STEPHEN W. COLEMAN
ENVIRONMENTAL CONSULTING, LLC

MEMORANDUM

To: Ms. Ingrid Richards, Chairperson
Town of Ossining Planning Board
From: Stephen W. Coleman
Re: **Artis Senior Living, LLC, 553 North State Road, Briarcliff Manor,
Town of Ossining - review of wetland delineation, application
materials and plans, potential wetland impacts and recommended
mitigation measures**
Date: July 7, 2015
cc: S. Donnelly, Supervisor, D.Stolman, FPCA

ARTIS - Field sketch plan -

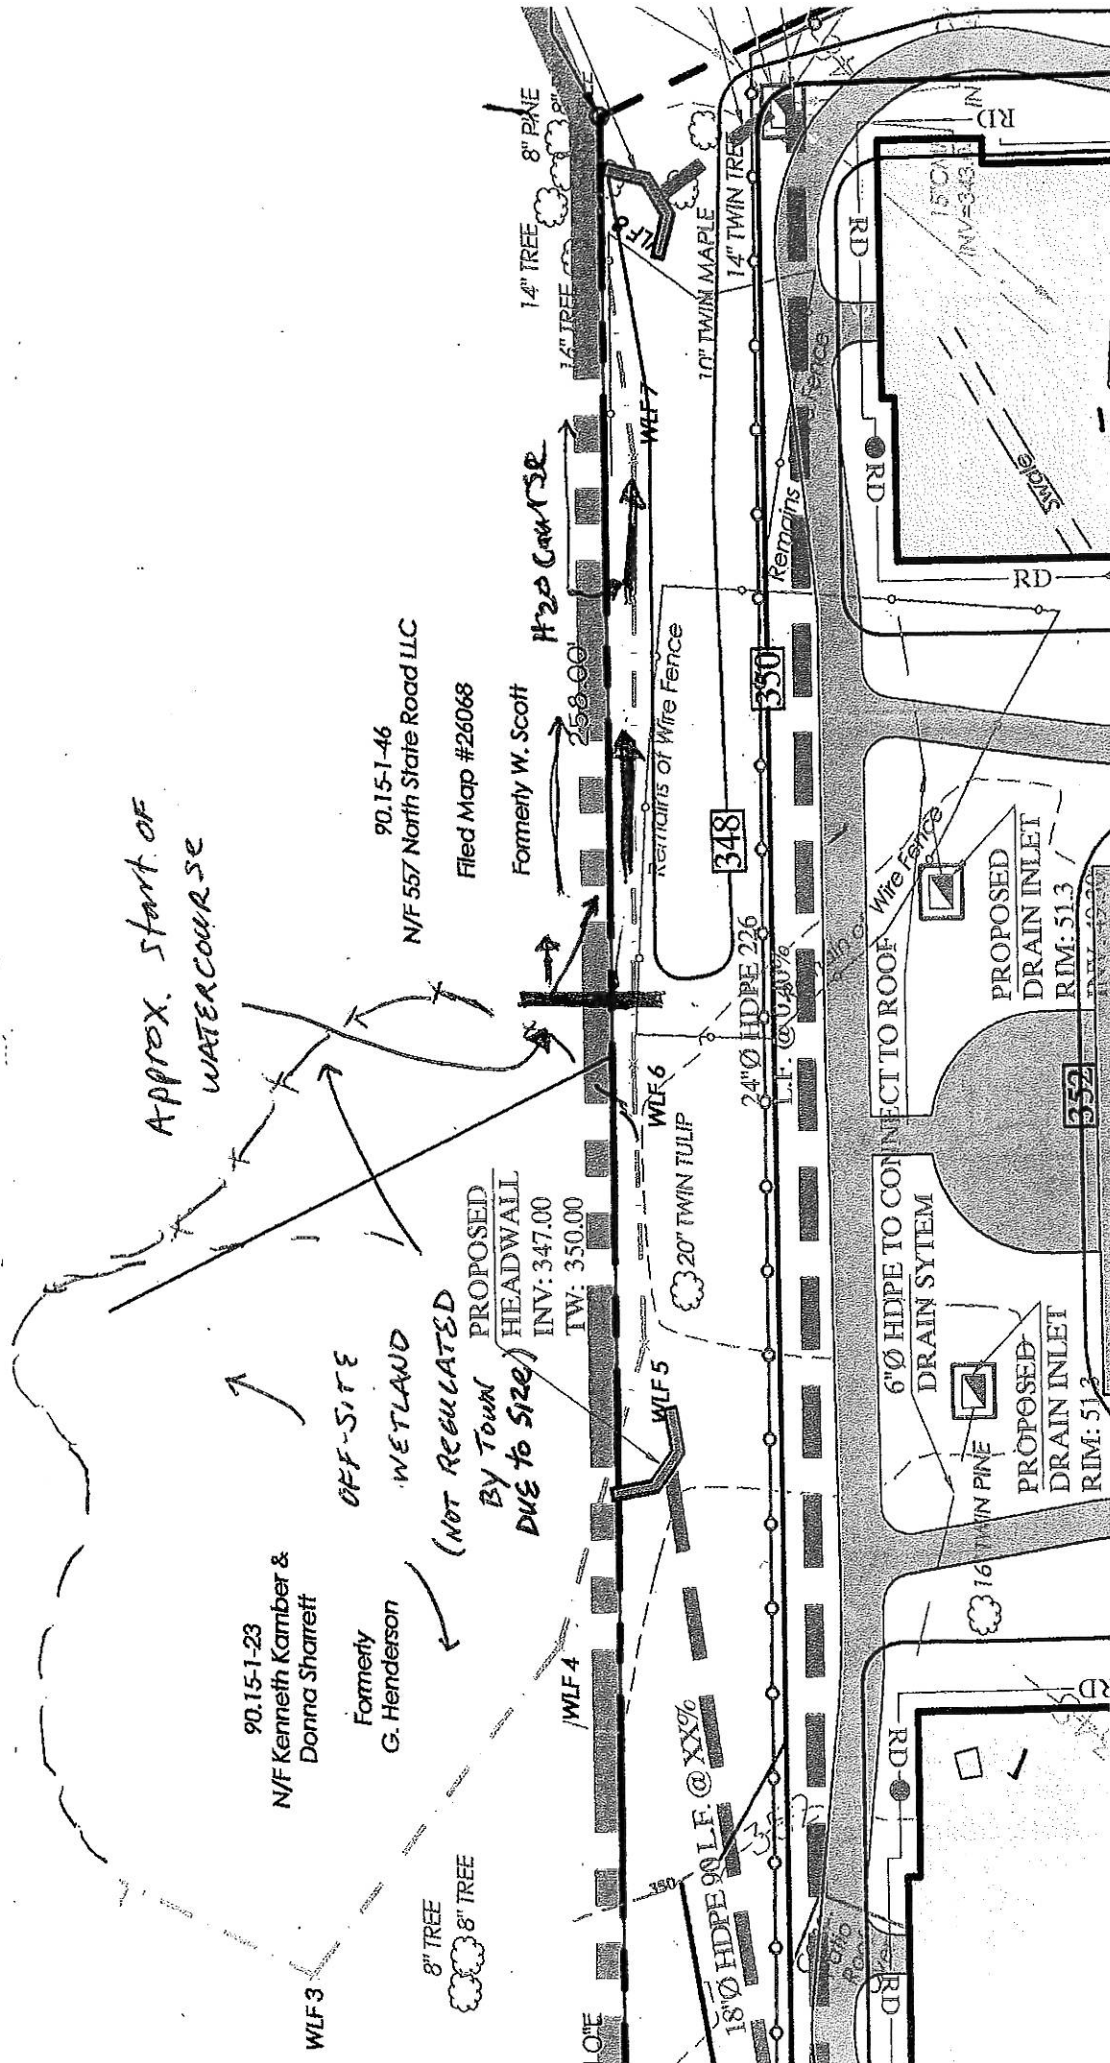
The presence of the intermittent watercourse that discharges from the adjoining wetland meets the criteria outlined in Chapter 105 of the Town Code of the Town of Ossining to be classified as a wetland. The intermittent watercourse channel continues along the property line and discharges into the existing culvert in the northeastern corner of the parcel. The watercourse where it discharges from the forested wetland would be subject to a 50 foot buffer (see attached field sketch that shows the approximate location of the intermittent watercourse).

The watercourse channel is located at the base of the existing berm. The entire berm surface is dominated by invasive plant species consisting of Japanese Knotweed and Multi-flora rose. The intermittent watercourse channel exhibits sufficient flow characteristics as evidenced by clear scouring of the bottom of the channel, the lack of vegetative growth within the bottom, and defined banks on both sides of the channel. The flatness of the bottom of the channel allows water to accumulate and remain saturated long after storm events.

WETLAND LOCATION SKETCH

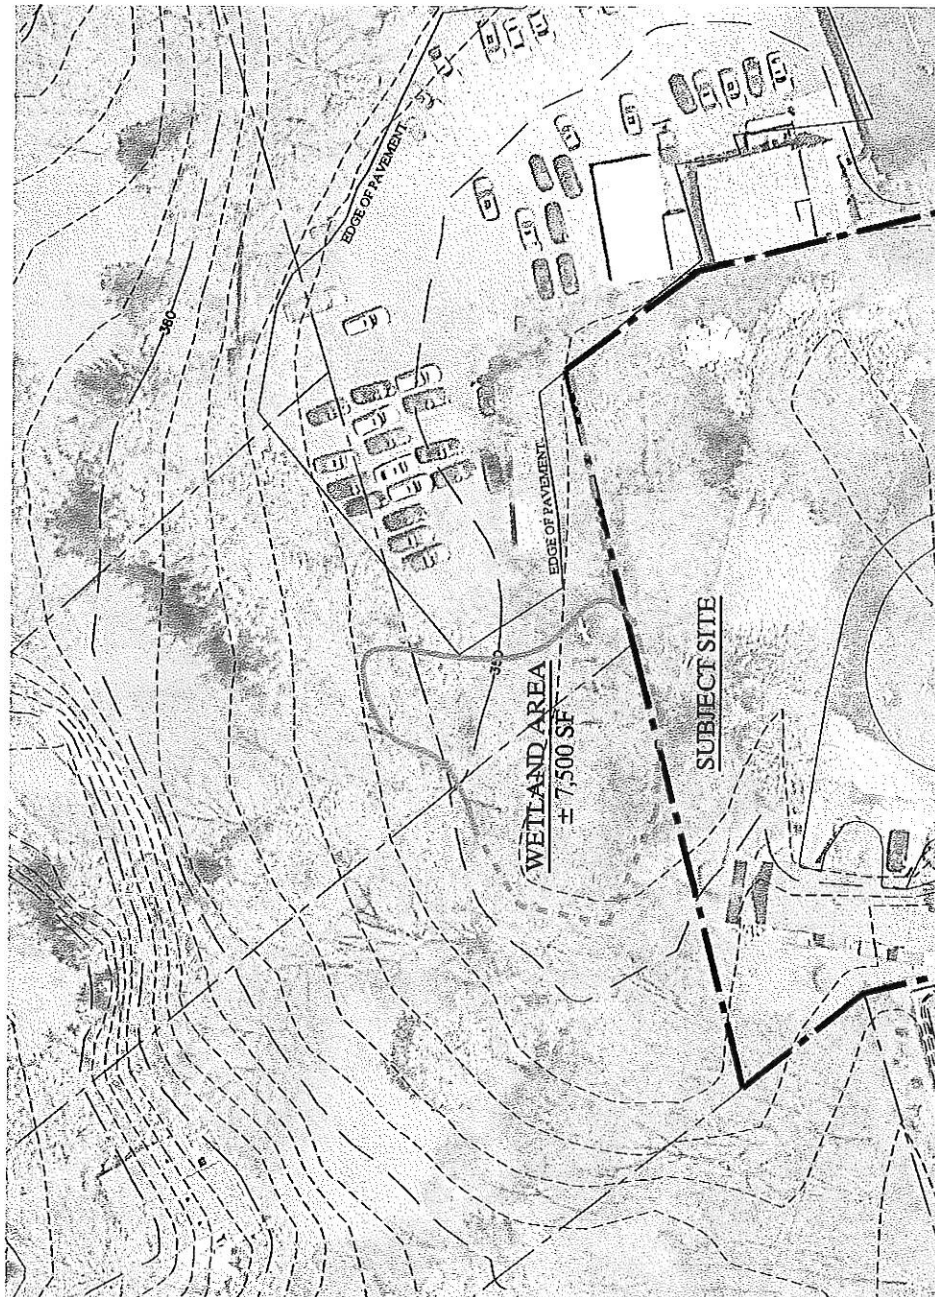
The forested wetland that is located primarily off-site on the adjoining properties, has been determined to be less than the required size threshold of ½ acre, as per Chapter 105 of the Code of the Town of Ossining. On 05-27-2015, I determined in the field the approximate outer boundary of the off-site wetland. I requested that Dave Sessions, Kellard Sessions, provide a follow up field map that verifies the field determination of the approximate wetland boundary. I have received a follow up "Wetland Location Sketch", dated 06-30-15, as prepared by Kellard Sessions that shows the extent of the wetland

acreage. The size of the wetland is approximately 7,500 square feet, which is under the size threshold, and therefore not considered regulated by the criteria outlined in Chapter 105.
